Log # TXX-89577
File # 10010
908.3
Ref. # 10CFR50.34(b)

SUBJECT: COMANCHE PEAK STEAM ELECTRIC STATION (CPSES)
DOCKET NOS. 50-445 AND 50-446
ADVANCE FSAR SUBMITTAL
UPGRADE AND ADDITION OF CLASS 1E ELECTRICAL
EQUIPMENT IN THE PRIMARY PLANT VENTILATION
SYSTEM TO MAINTAIN NEGATIVE PRESSURE

Advance FSAR Change Regarding the Upgrade and Addition
of Class 1E Electrical Equipment in the
Primary Plant Ventilation System
to Maintain Negative Pressure

FIGURE 8.3-11, SH.1

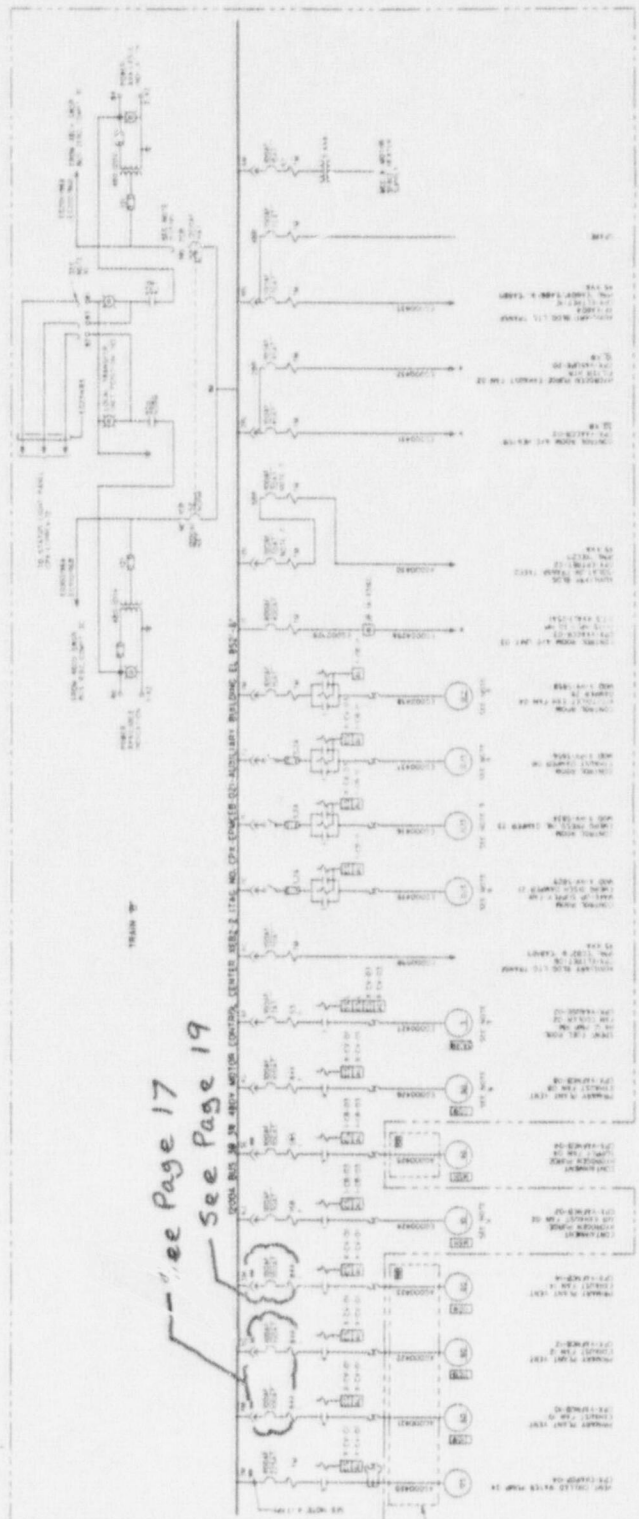
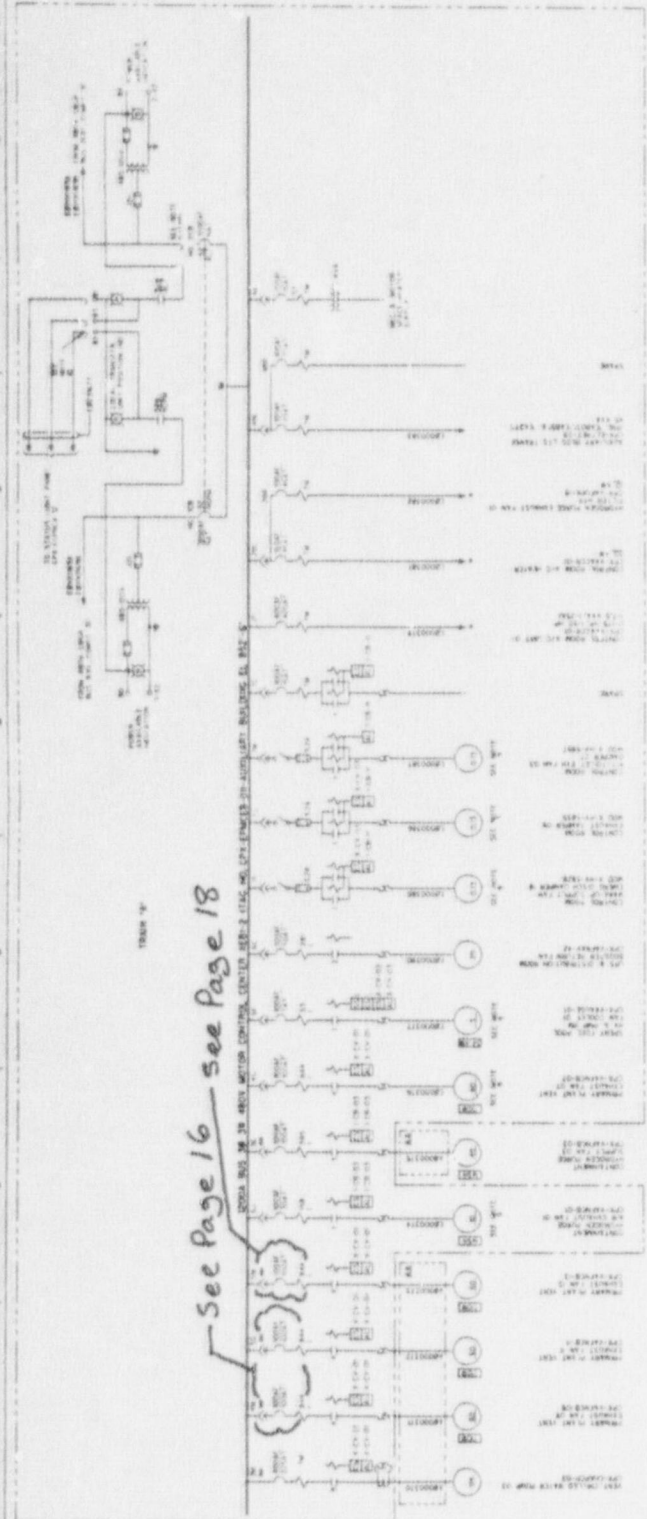
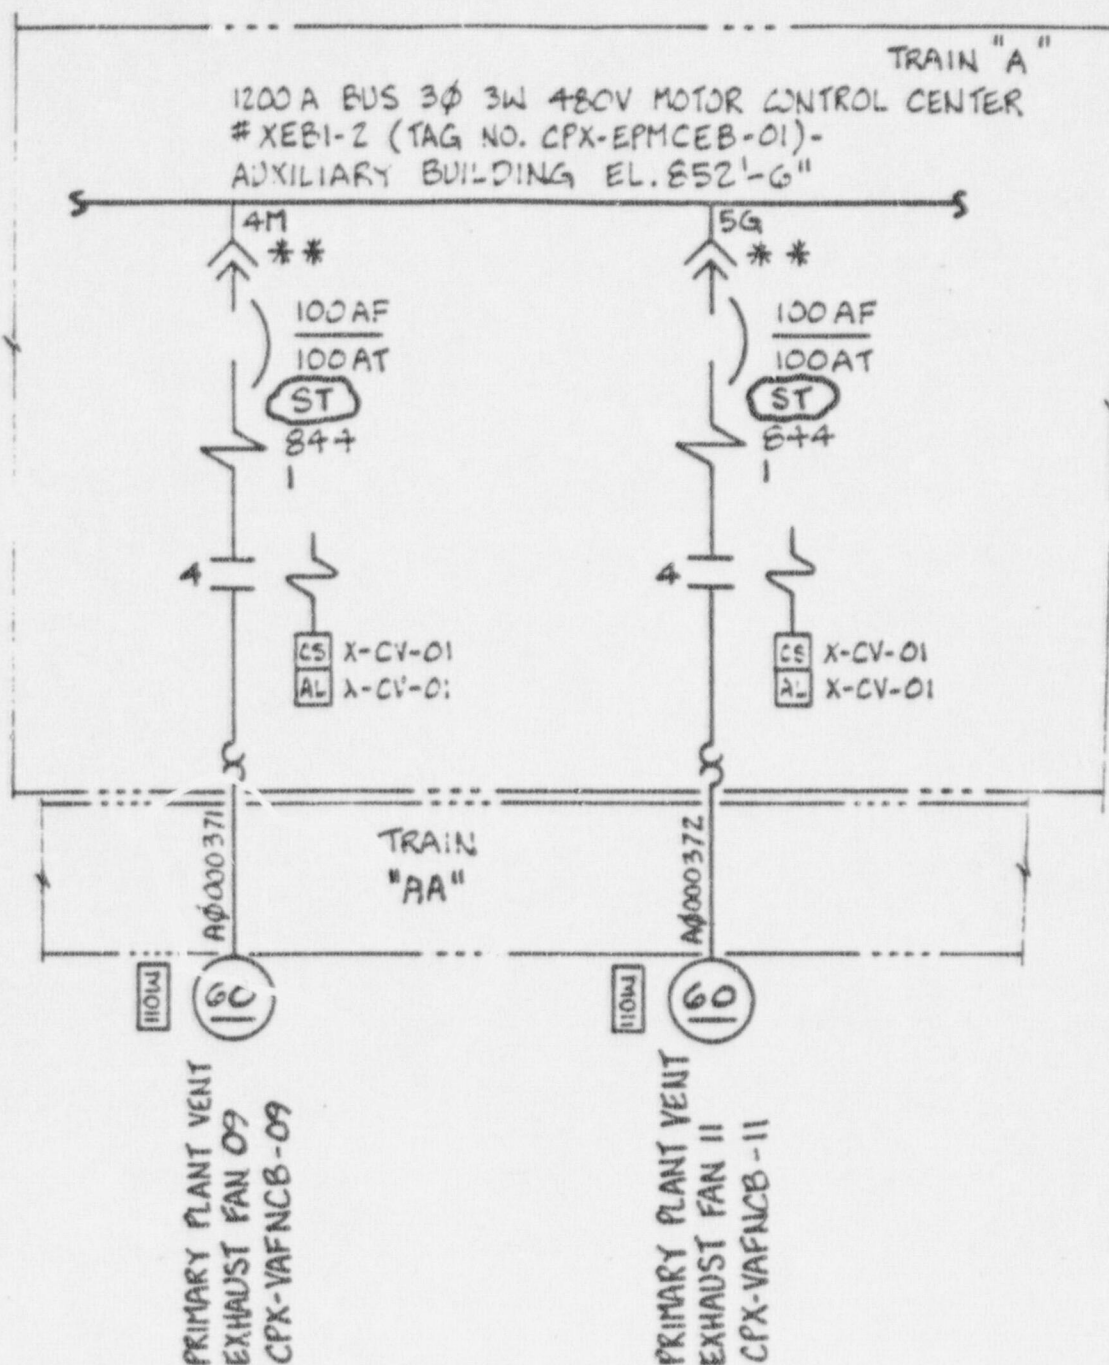
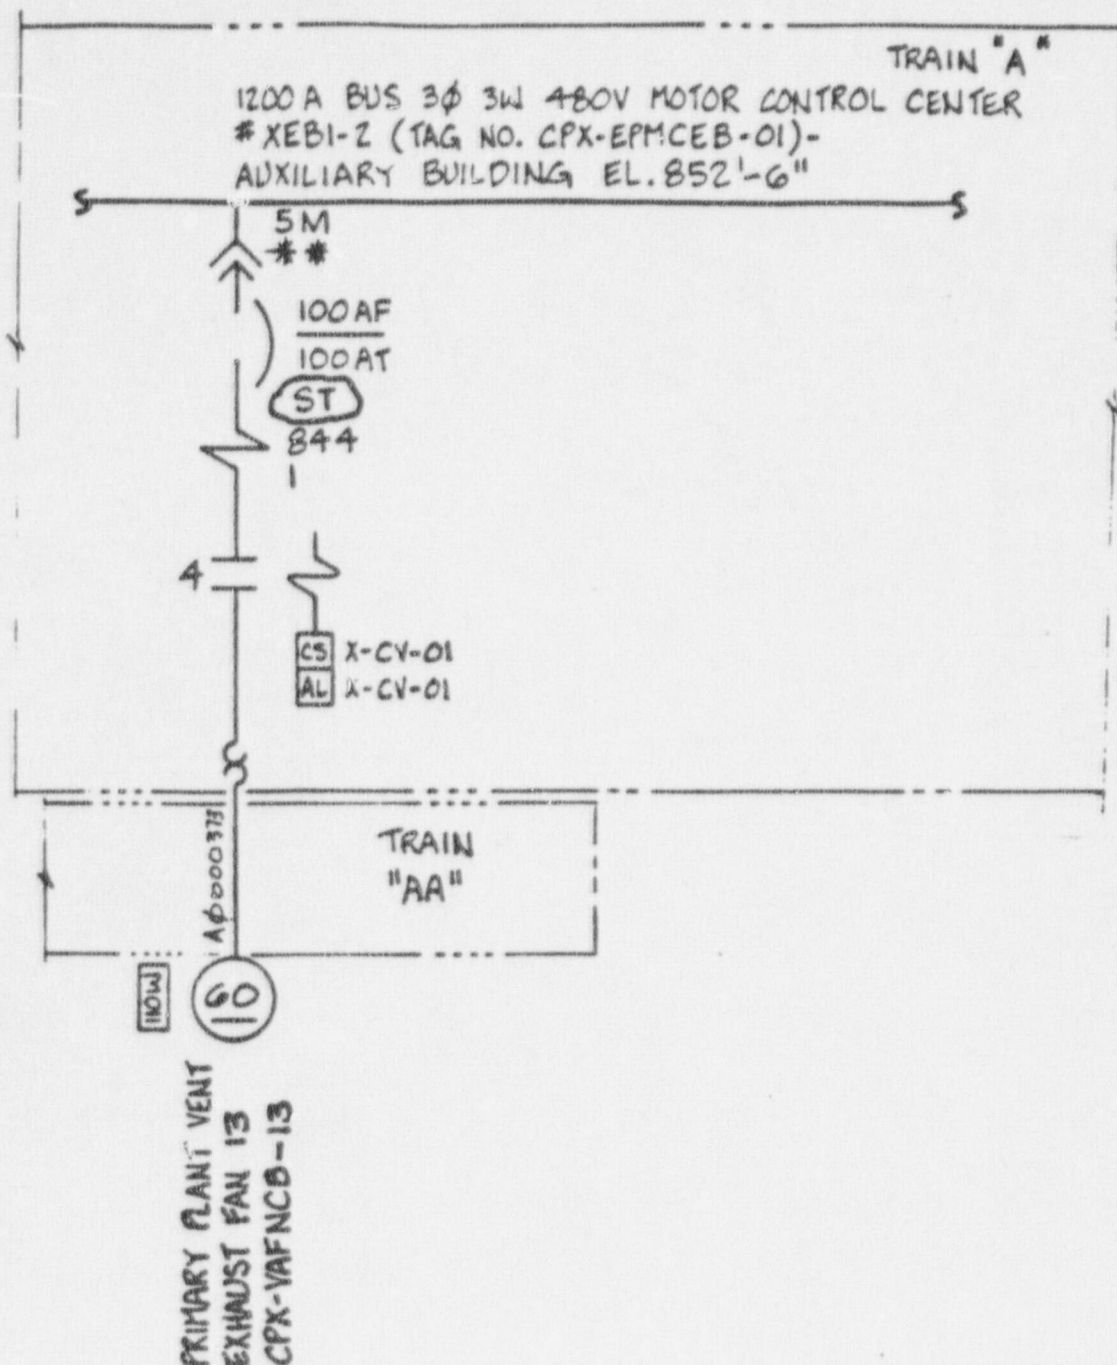
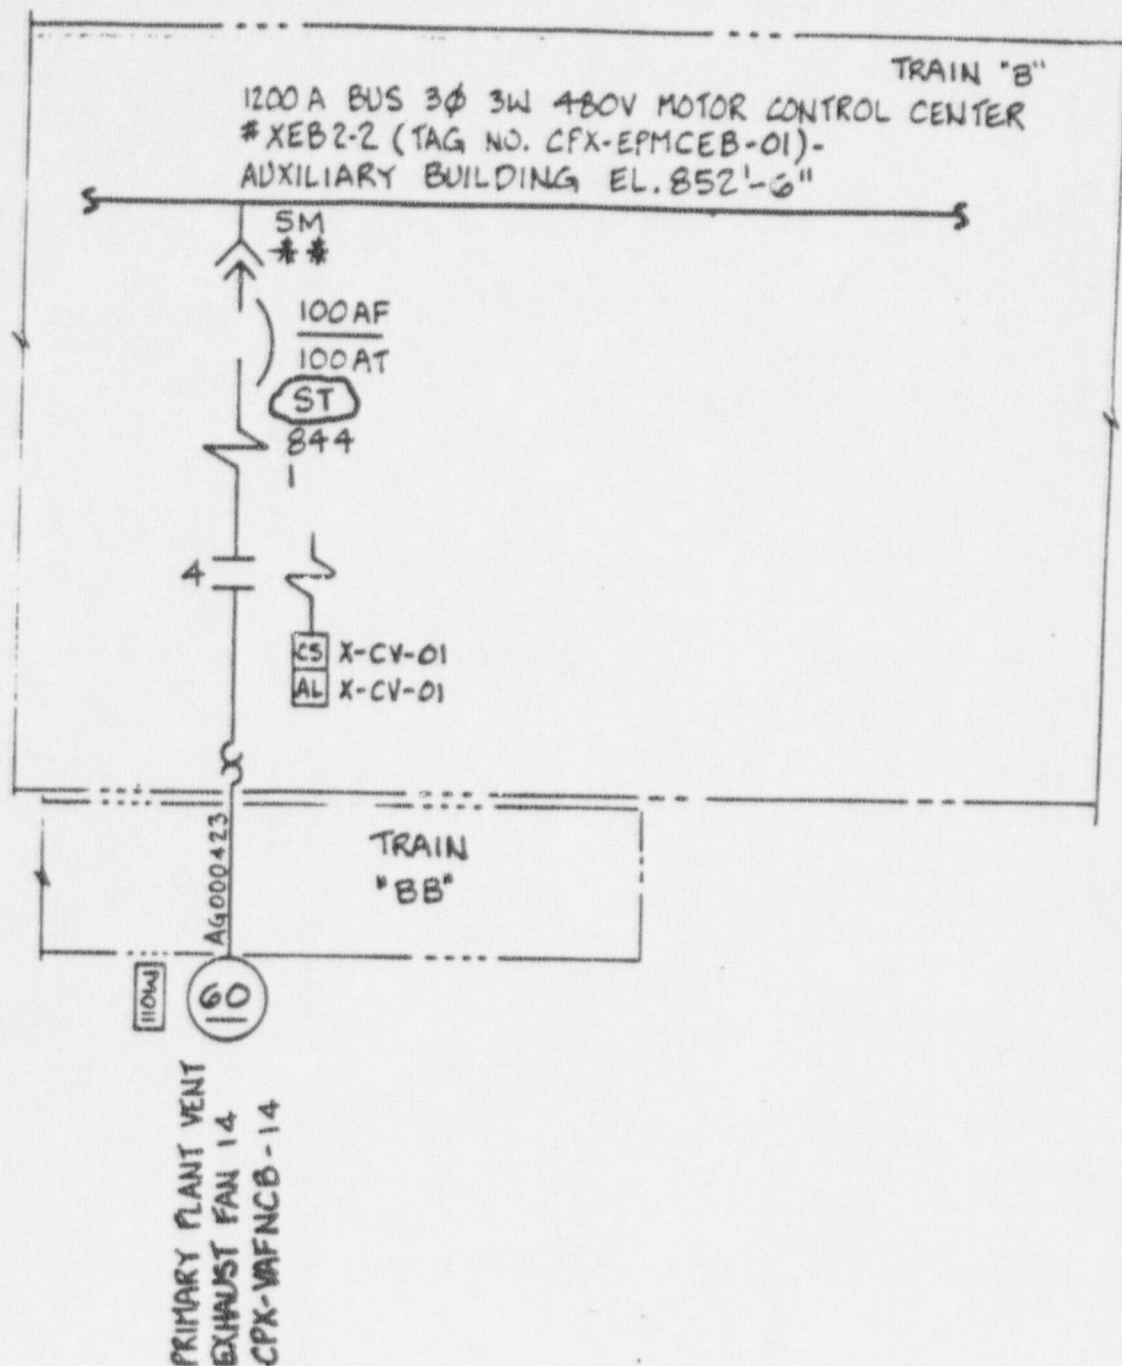
- 2 See Sheet No(s):1
Adds "S" signal trip to the breakers associated with each of the following Primary Plant Ventilation Exhaust Fans (CPX-VAFNCB-09, 11, & 13) in Compartments 4M, 5G, & 5M of 480V MCC XEB1-2, respectively.

- 2 See Sheet No(s):1
Adds "S" signal trip to the breakers associated with each of the following Primary Plant Ventilation Exhaust Fans (CPX-VAFNCB-10, 12, & 14) in Compartments 4M, 5G, & 5M of 480V MCC XEB2-2, respectively.
Revision:
The Primary Plant Ventilation (PPV) System has been modified by upgrading two installed PPV Exhaust Fans to Class 1E, removing the "S" signal trip from the fans' circuitry, upgrading the fans' power cables to Class 1E, and adding shunt trip devices to certain non-Class 1E Exhaust/Supply fan circuitry. The two upgraded PPV Exhaust Fans and their power cables were originally procured as Class 1E and the power cables are routed in Class 1E raceways. The addition of the shunt trip devices provides electrical isolation between the non-Class 1E PPV Exhaust Fans and the Class 1E power source consistent with Reg. Guide 1.75 and FSAR Section 8.3. The shunt trip devices will cause the fans to trip upon receipt of an "S" signal. The purpose of the modification is to provide additional margin relative to the negative pressure required to be achieved and maintained in the negative pressure envelope during a LOCA or LOOP.
